EPA
Environmental Licensing Programme
Office of Environmental Sustainability

Reg. No.: W0146-04 Knockharley Landfill

Further to the Agency's correspondence of the 1st of November, we wish to make the following response to items 1-10. A separate response will be submitted in relation to the queries raised in item 2 as this requires work from a UK based olfactory assessment consulting firm.

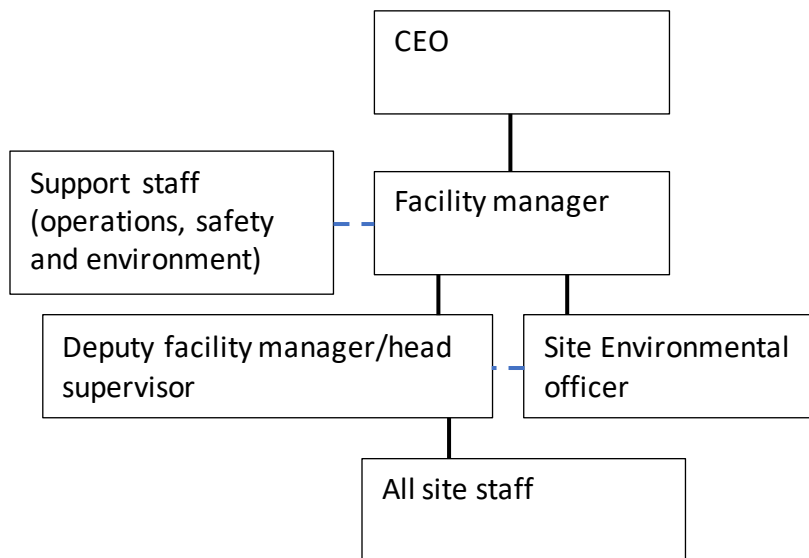
1. *Revised Attachment 2-5-1 Technical Knowledge submitted on 07 September 2021 does not provide details in relation to the Deputy Facility Manager or the management structure and organisation chart. In accordance with the [licence application guidance](#), provide the following [Regulation 9(2)(h)]:*

- (a) Details of the Deputy Facility Manager's name, duties and responsibilities and experience/qualifications;*
- (b) Information in relation to the management structure and an organisational chart.*

Sean Smith is facility manager, he is assisted by Michael Noone. Aaron Coyle is environmental officer for the facility. Sean reports to Beuparc CEO Brian McCabe. Support for Knockharley landfill is provided by Joe Nicholson, group Safety Manager; David Naughton group environmental manager, David Tobin Sustainability and Circular Economy Director and; Kieran Connor, group processing manager.

An organisational chart is provided below.

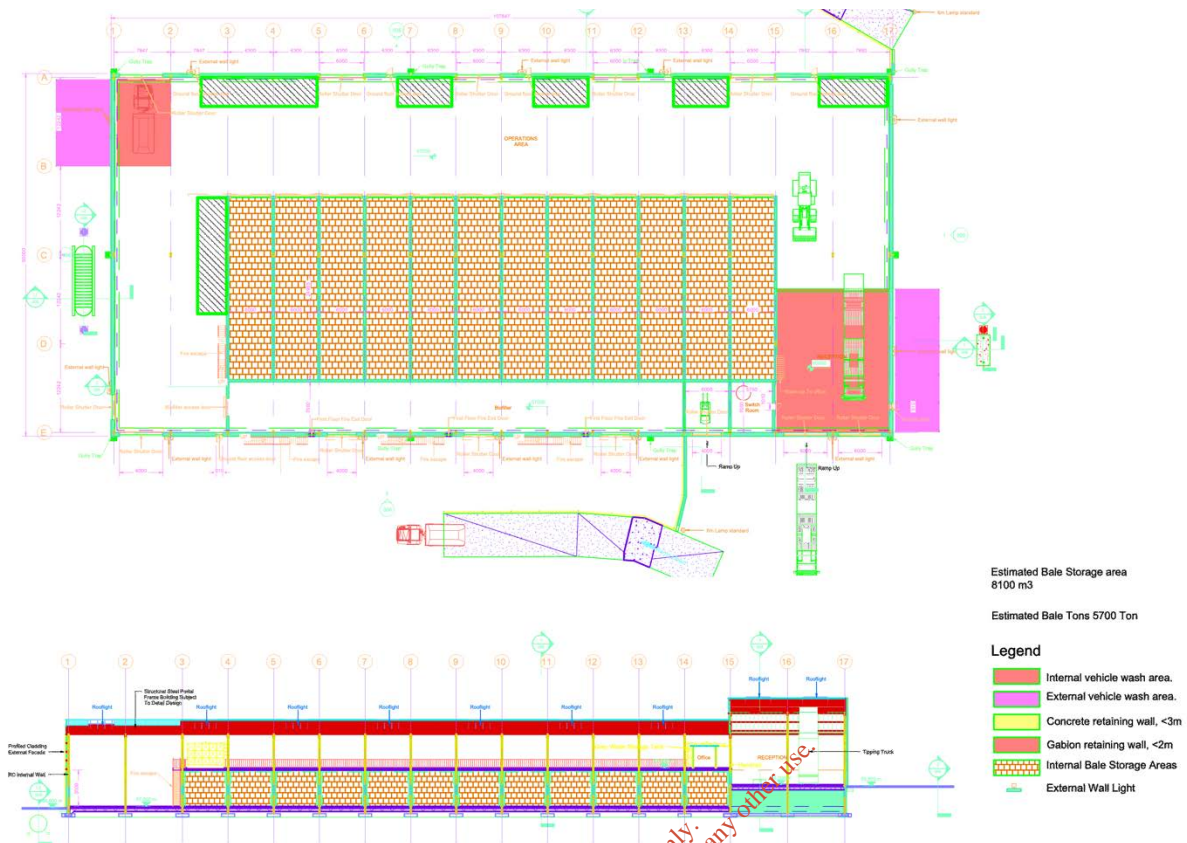
9. It is noted that the biological treatment facility will be designed to accommodate storage of baled recyclables and baled MSW on the ground floor and above the compost tunnels. Provide a drawing showing the storage locations and the maximum quantity of waste to be stored in each of the storage areas [Regulation 9(2)(g)].

Please see below drawing showing the bale storage areas and the volumes/weights to be stored.
